Mobile Intel® Celeron® Processor on .13 Micron Process in Micro-FCPGA Package

Specification Update

November 2004

Document Number: 251309-024

Figure 12. System Bus Reset and Configuration Timings

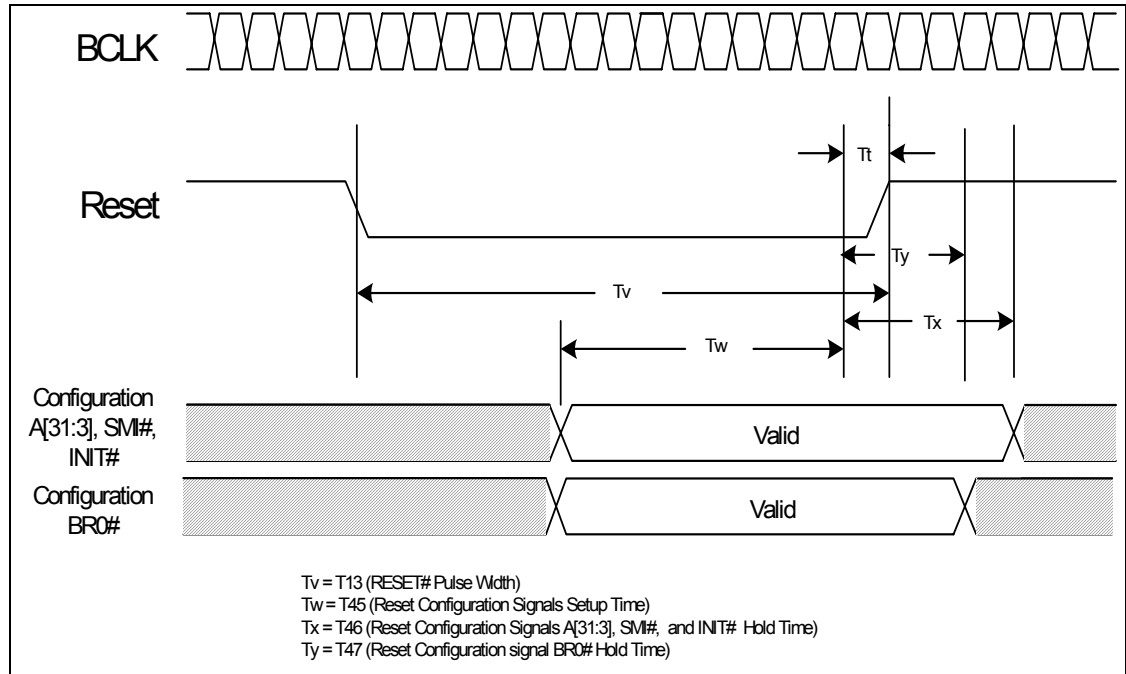
V2. BR0# Maximum Hold Time Specification Change

The BR0# maximum hold time has changed to 2 BCLKs. This change will be shown in the “System Bus AC Specifications (Reset Conditions)” table and “System Bus Reset and Configuration Timings” figure of the *Mobile Intel® Celeron® Processor on .13 Micron Process in Micro-FCPGA Package Datasheet*. This change will be incorporated in the next revision of the datasheet.

The following figure will be modified to reflect this change:

T# Parameter	Min	Max	Unit	Figure	Notes
T45: Reset Configuration Signals (A[31:3]#, BR0# INIT#, SMI#) Setup Time	4		BCLKs	13	1
T46: Reset Configuration Signals (A[31:3]#, INIT#, SMI#) Hold Time	2	20	BCLKs	13	2
T47: Reset Configuration Signal BR0# Hold Time	2	2	BCLKs	13	2

1. Before the deassertion of RESET#.
2. After clock that deasserts RESET#.
